PROJECT NUMBER: 1000965
Application Number: 04EPC-00855 / 05-0285

Amended Site Plan for Subdivision

PROJECT # 1000965

Andalusia at La Luz

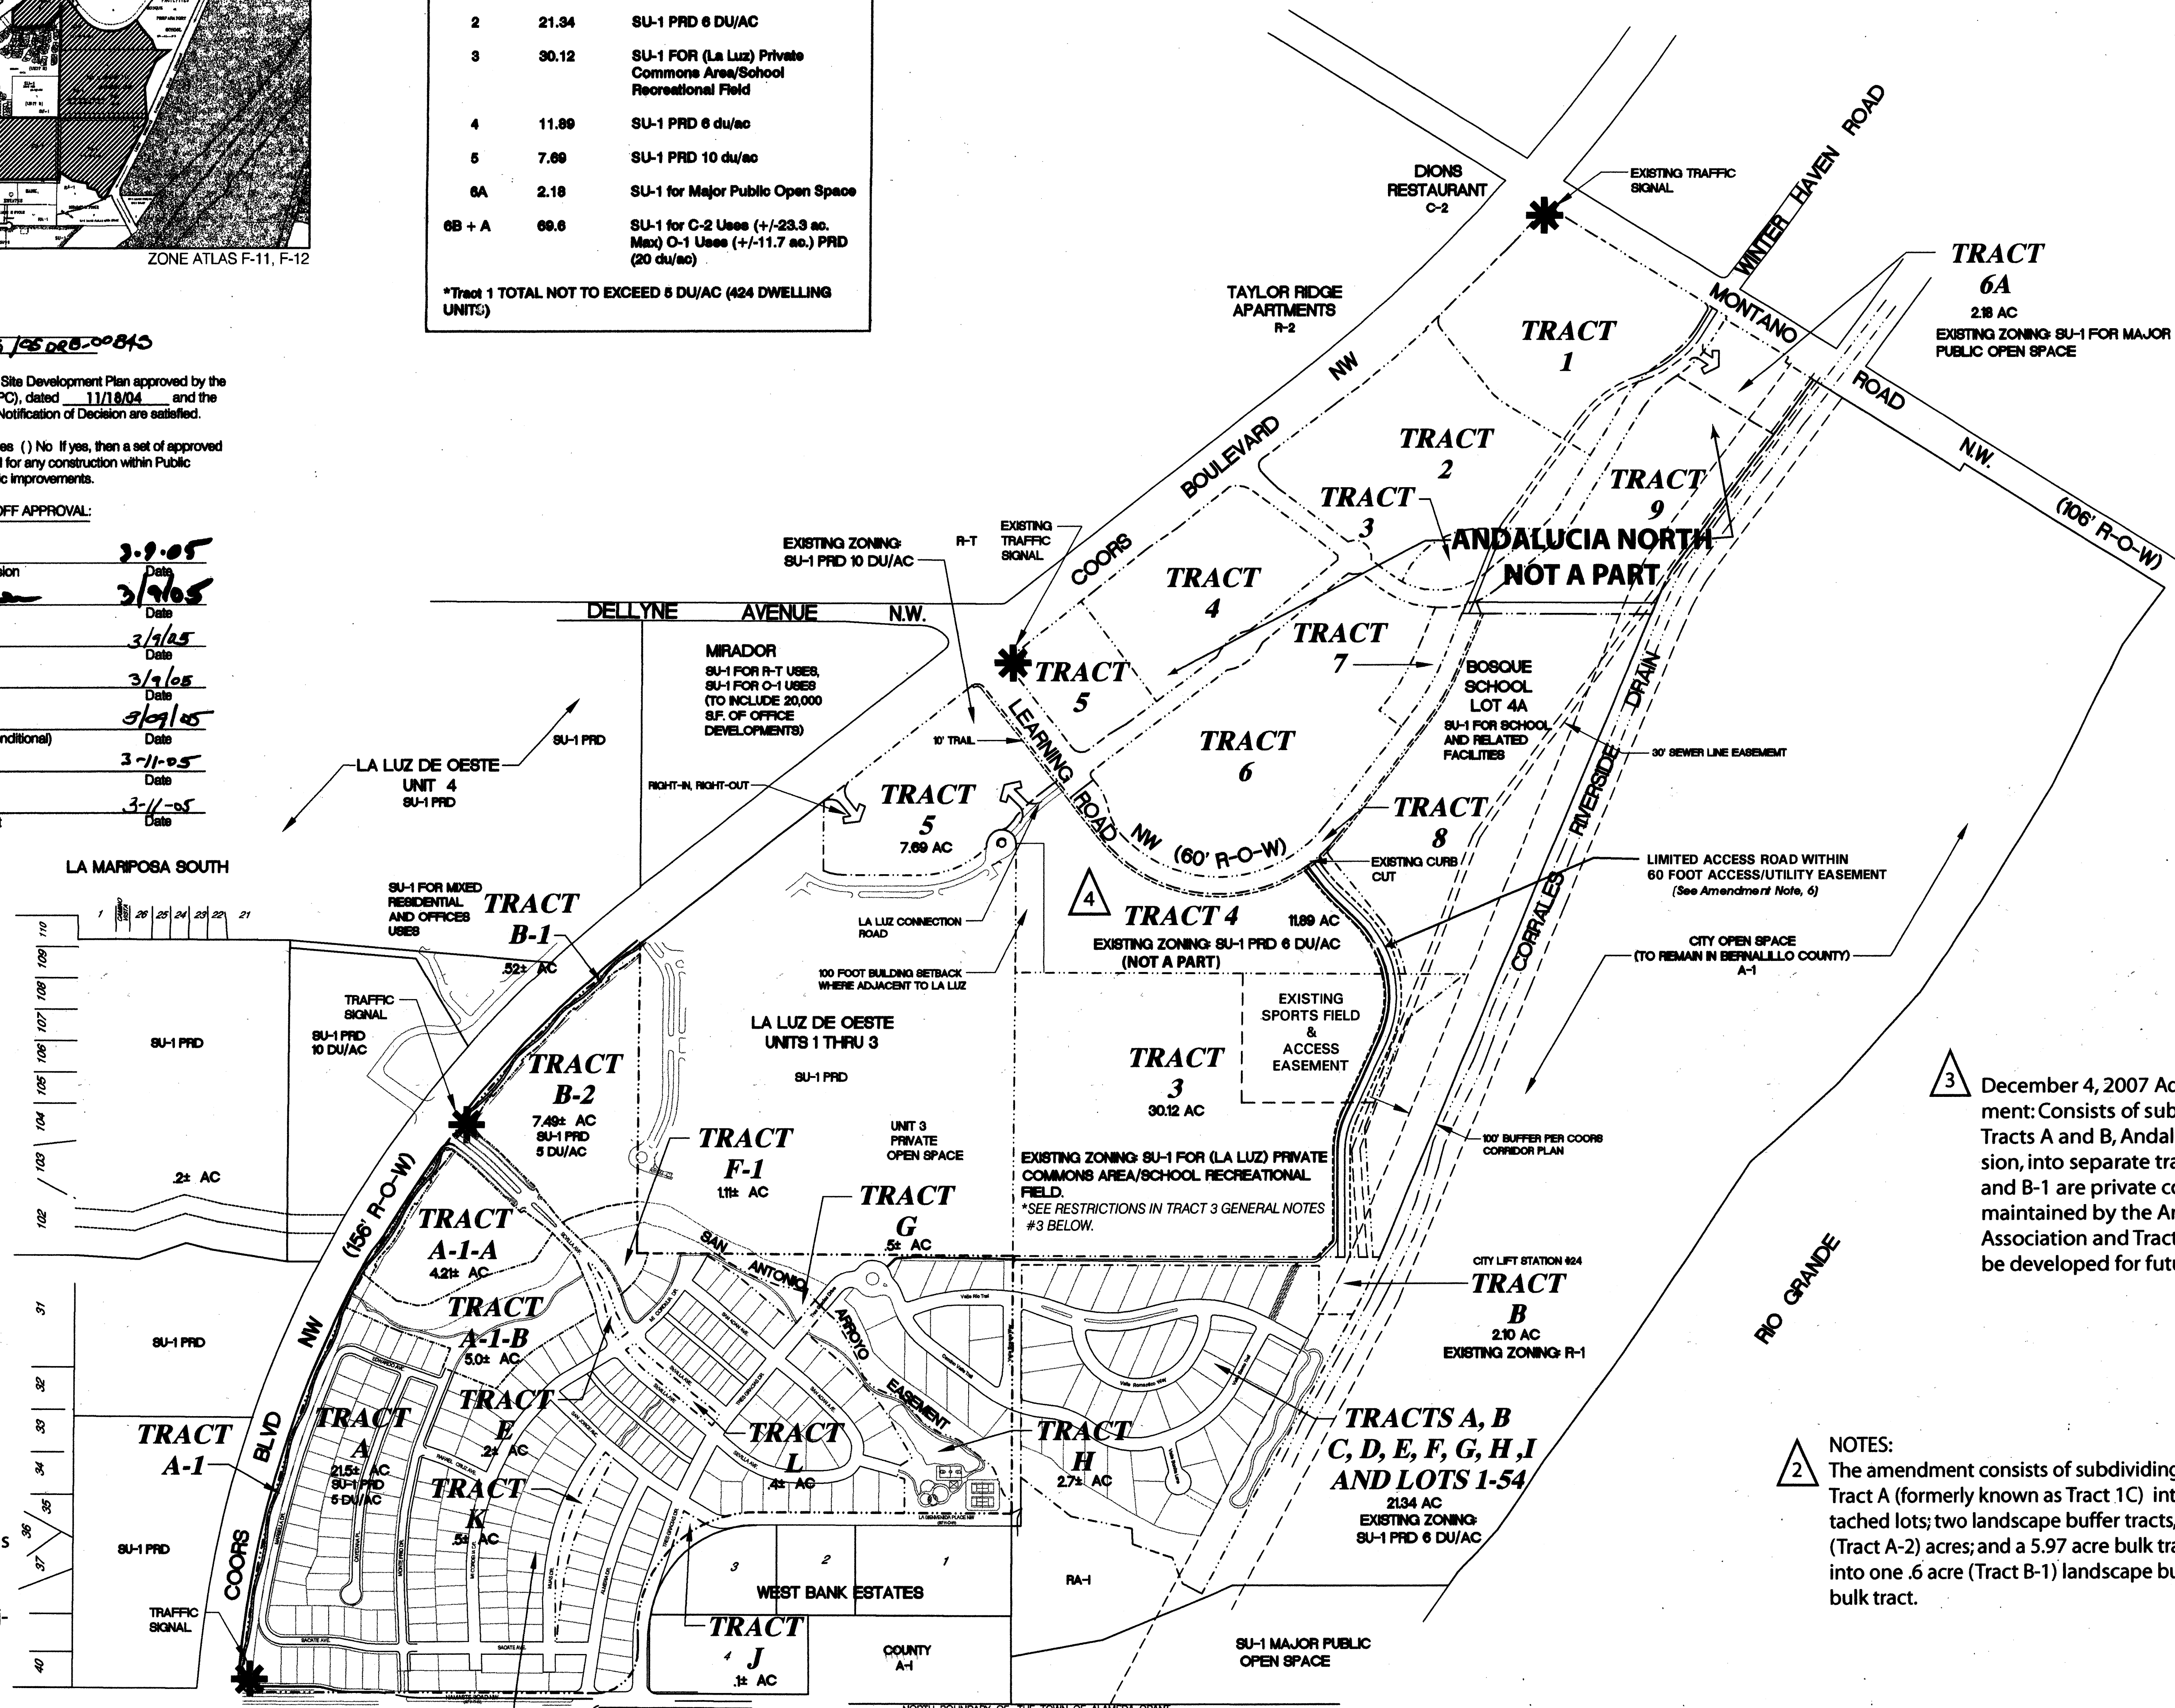
ADMINISTRATIVE AMENDMENT - 1/18/05
Tracts 6B and A have been removed from this Site Plan for Subdivision and a new Site Plan for Subdivision has been created for those two tracts - Project #100965, 04EPC 01845.

May 1, 2008 Amendment:
Consists of removing Tract 4 from this Site Plan for Subdivision. Tract 4 has been consolidated into the Boque School Site Plan for Subdivision, Project 1000901; 08EPC-40051.

- Tract 1B is subdivided into 13 single family lots and Tract 2 is subdivided into 41 single family lots.
- The Private Recreation Area within Tract 1A has been replaced with 3 single family residential lots.

- A minor adjustment to the Tract 4 northwest boundary of the La Luz Connection Road.
- A minor adjustment to the Tract 1D boundary at the entry road to La Luz subdivision.

- Clarification that the gross density for Tract 1 shall not exceed 5 du/ac and that individual tracts (Tracts 1A, 1B, 1C, 1D, and 1E) may exceed this density provided the gross density for Tract 1 as a whole is maintained.

- The 60 foot Access/Utility Easement shall contain a 24 foot limited access road and a 10 foot public trail. The easement is restricted to pedestrian/bicycle/equestrian, emergency fire access, City Lift Station access for operations and maintenance only, public water and sanitary sewer easement and utilities of all types, and drainage. The road shall be an all-weather, gravel surfaced facility, have no lighting, and shall be gated. There shall be no public vehicular access. A pipe rail fence shall be installed on the western edge of the easement along Tracts 3 and 4. Final roadway, trail, and fence layout shall be completed prior to final sign-off of the Site Plan by the Development Review Board.

NOTES:
The amendment consists of subdividing a 13.95 acre portion of Tract A (formerly known as Tract 1C) into 61 single family detached lots; two landscape buffer tracts, 1.2 (Tract A-1) and .38 (Tract A-2) acres; and a 5.97 acre bulk tract. Tract B is subdivided into one .6 acre (Tract B-1) landscape buffer tract and a 7.7 acre bulk tract.
